**A&M Project #:** 2889-01  
**Re:** Skyview Estates  
Special Permit /  
Site Plan Review  
Town & Engineer Comments  
651 Main Street  
Map 21/Parcel B5.1

Please find Allen & Major Associates, Inc. (A&M) responses to the review letter prepared by Quinn Engineering Inc., dated January 3, 2023, in reference to the Skyview Estates Major Site Plan Review and Special Permit Applications, to be located along Main Street in Leicester, Massachusetts.

**DRAWING TITLE:** PROPOSED WATERSHED PLAN  
**\* OVERLAY DISTRICT ONLY \***

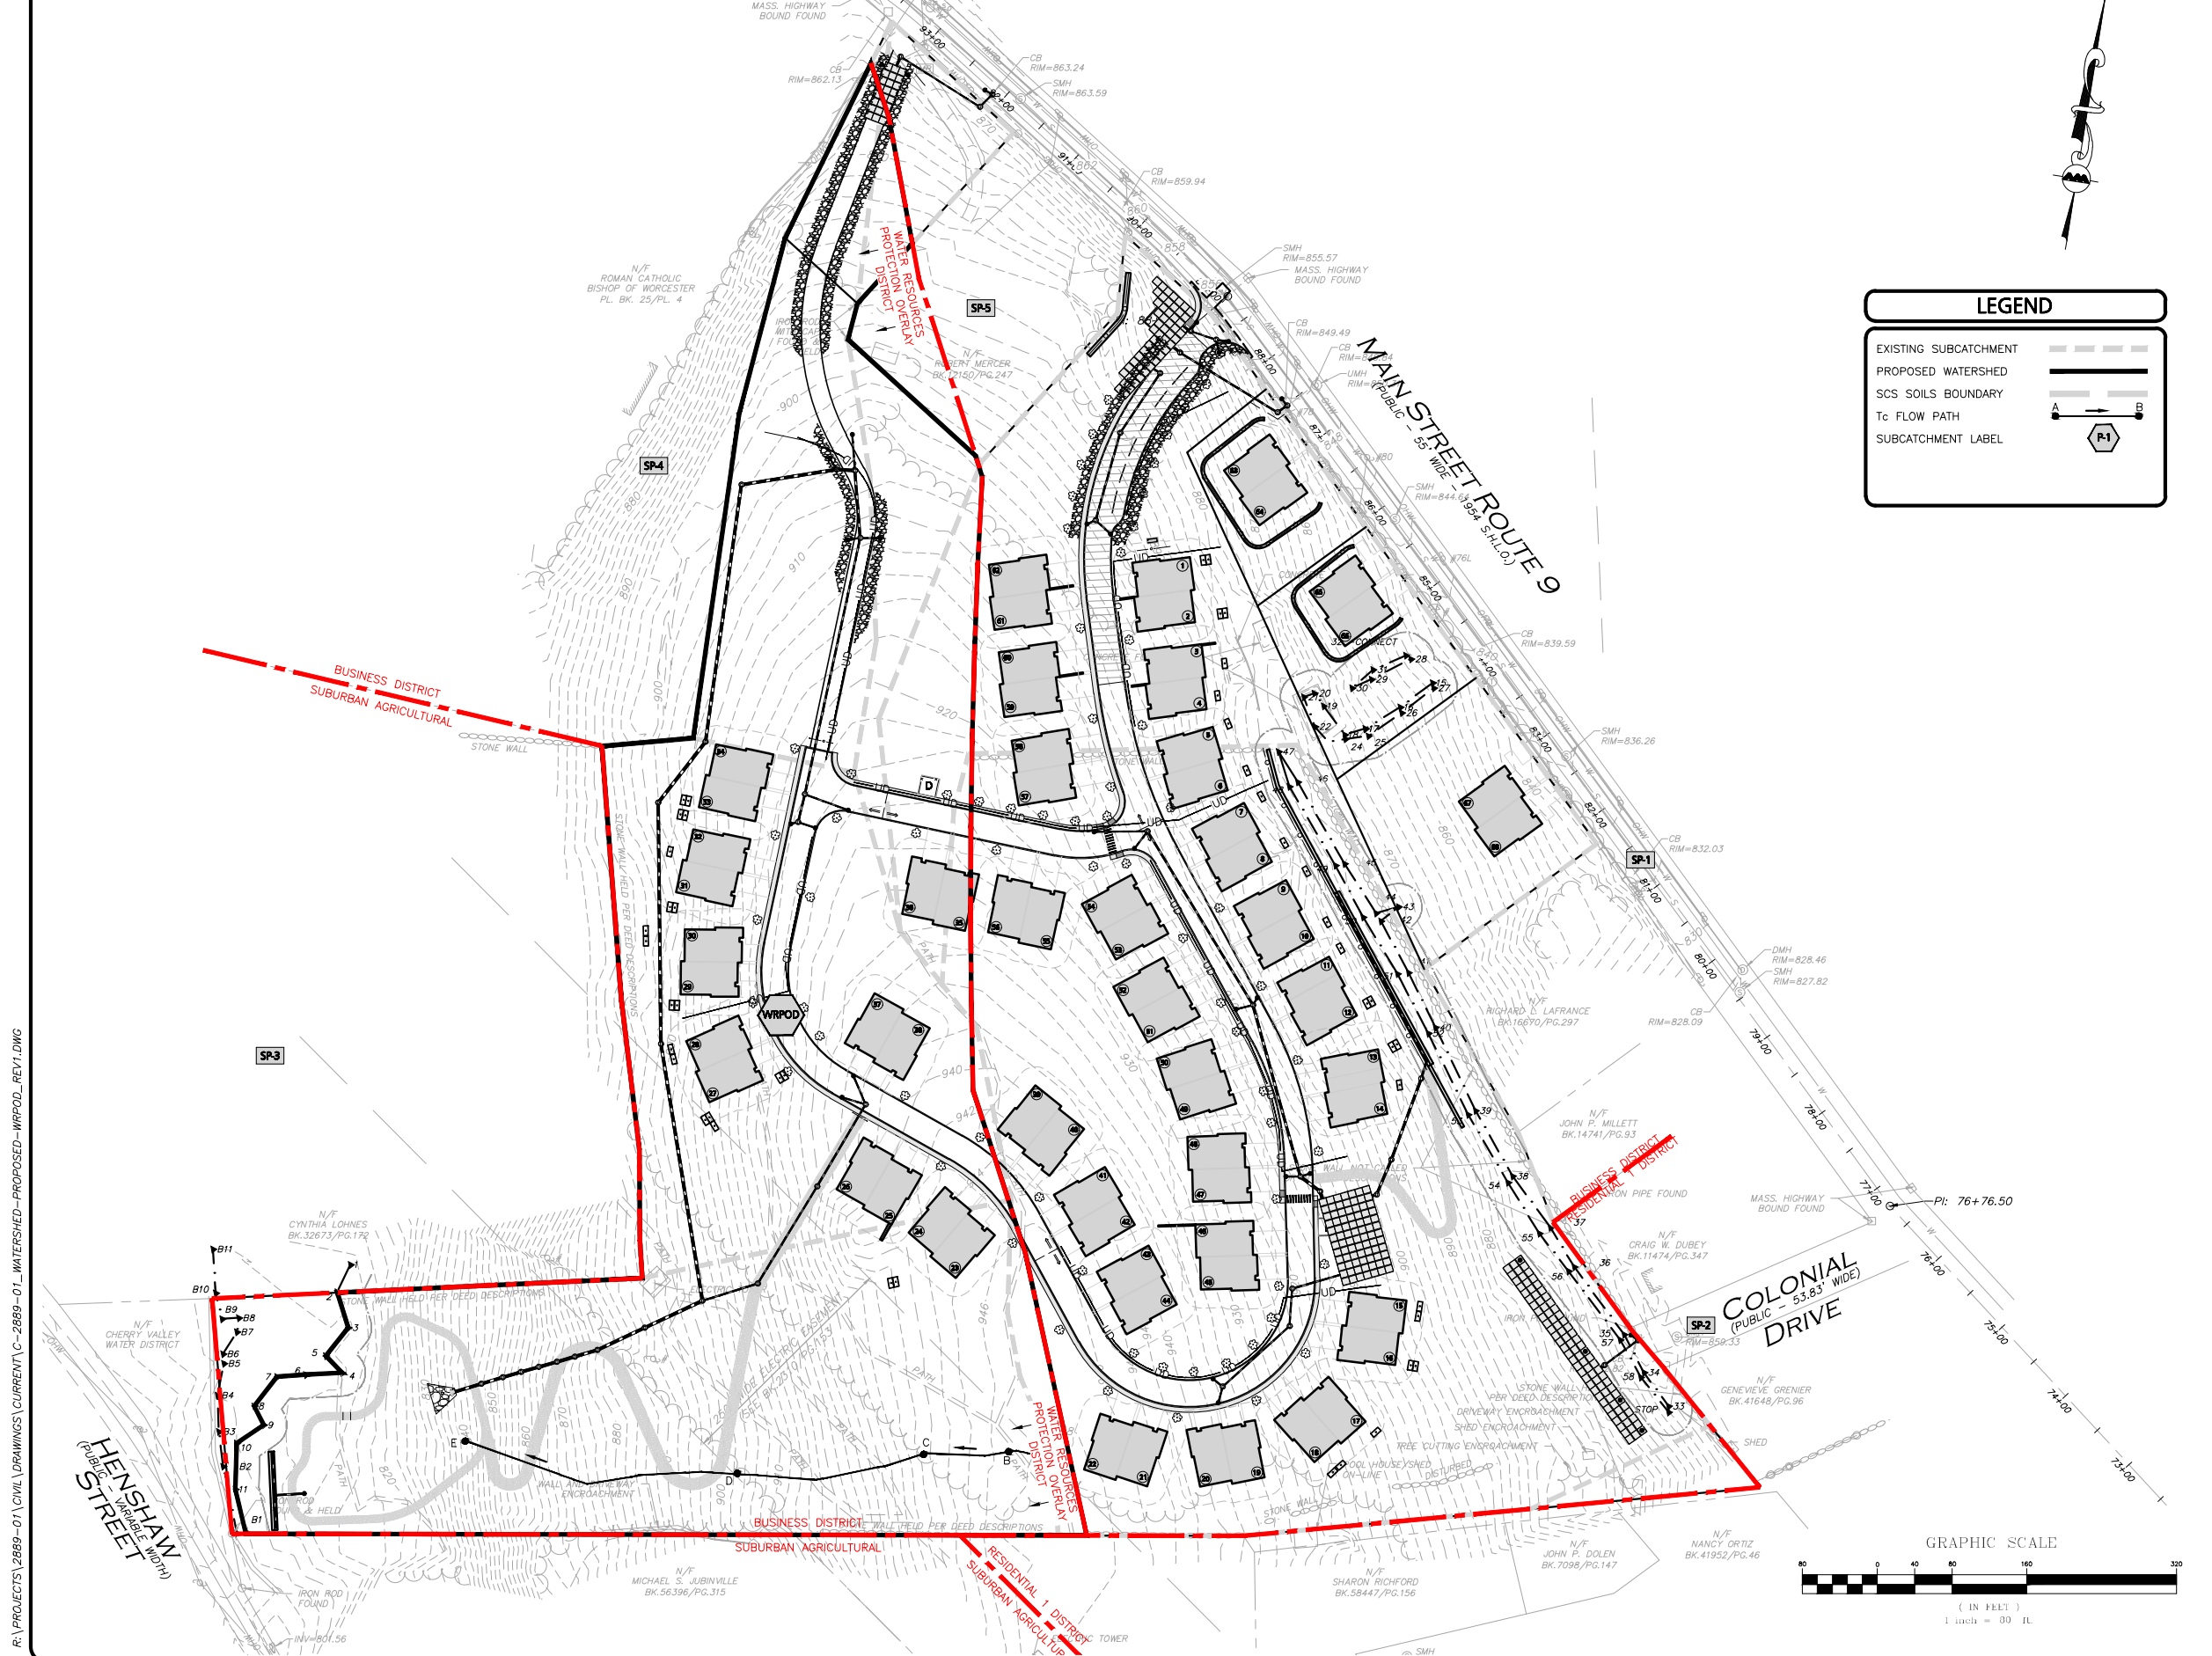
6. *Portions of the development are located within Water Resources Protection Overlay District (WRPOD). The Engineer is requested to document the percentage of area of impervious surfaces within the WRPOD and the need for a Special Permit.*

**Response: The area of impervious surfaces within the Water Resource Protection Overlay District is 14.69% as indicated in the previously submitted materials. As separate HydroCAD report was prepared to illustrate the areas within the overlay district only. This material was previously included in the updated drainage report (pages 349-354) and have been attached to this letter.**
